Staff Report & Recommendation

Design Review Board

SUBJECT: DRB21-0686
2464 Prairie Avenue

An application has been filed requesting Design Review Approval for the construction of a new two-story residence, including one or more waivers and variances from the maximum lot coverage, maximum unit size and maximum yard elevation, to replace an existing architecturally significant pre-1942 home.

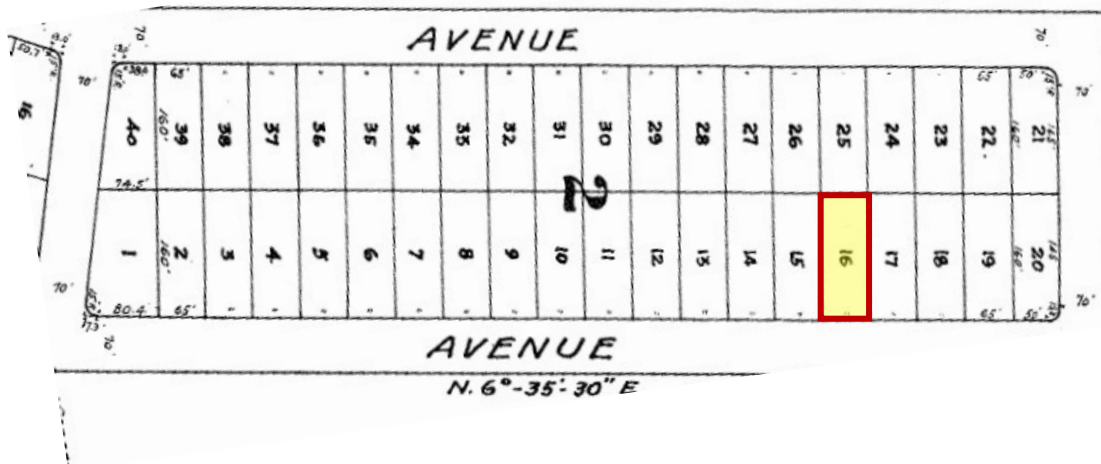
The applicant is proposing a new two-story single-family home that exceeds the maximum lot coverage and unit size allowed. The property is an interior lot containing 10,400 sf of area with a lot width of 65'-0". The subject lot exceeds the minimum size of 10,000 sf and minimum lot width of 60'-0" required for the RS-3 district. This property size is consistent and similar to all surrounding properties within Block 2 of the Mid Golf Subdivision, as noted in the original plat map below. The applicant's letter of intent indicates that the "narrow lot and the proximity to adjacent neighbors" present challenges for the design of the home.

However, based on the size and location of the property and the fact that this is new construction, staff finds that there are no special conditions on this property for the variances requested and the approval of these variances would confer a benefit to the applicant denied to other surrounding properties. The variances requested are not the minimum variances required to make a reasonable use of the property.

Staff would note that as part of the latest amendments to the single-family regulations last year, the lot coverage and unit size section was modified to remove courtyards enclosed on three (3) sides among other requirements. Terraces and covered areas also changed in the way they are counted and now all covered areas, eyebrows and roof overhangs exceeding 5'-0" from the building walls or columns shall count as part of the lot coverage. In this regard, staff believes that with minor modifications to the design, the lot coverage could be reduced to comply with the Code requirements. Specifically, at the rear terrace, the portion exceeding 5'-0" could be replaced with an open trellis, which removes this area from the total lot coverage. The excess in lot coverage proposed is 130 sf and this area exceeding 5'-0" is approximately 168 sf. With this change the lot coverage would be below the maximum 30% allowed.

In regard to the unit size, staff recommends that the proposed size of the home be reduced to comply with the Code. Although the intent of the program with an interior ramp is to facilitate access to the second-floor space without using a stair, staff believes that exploring other alternatives could reduce the unit size of the home. For example, some of the living area can be located below the ramp to take advantage of the double height space, or the footprint of

the ramp could be reduced to a more concentrated space and reduce the area of the double height space. The foyer appears rather large and could also be reduced in size.
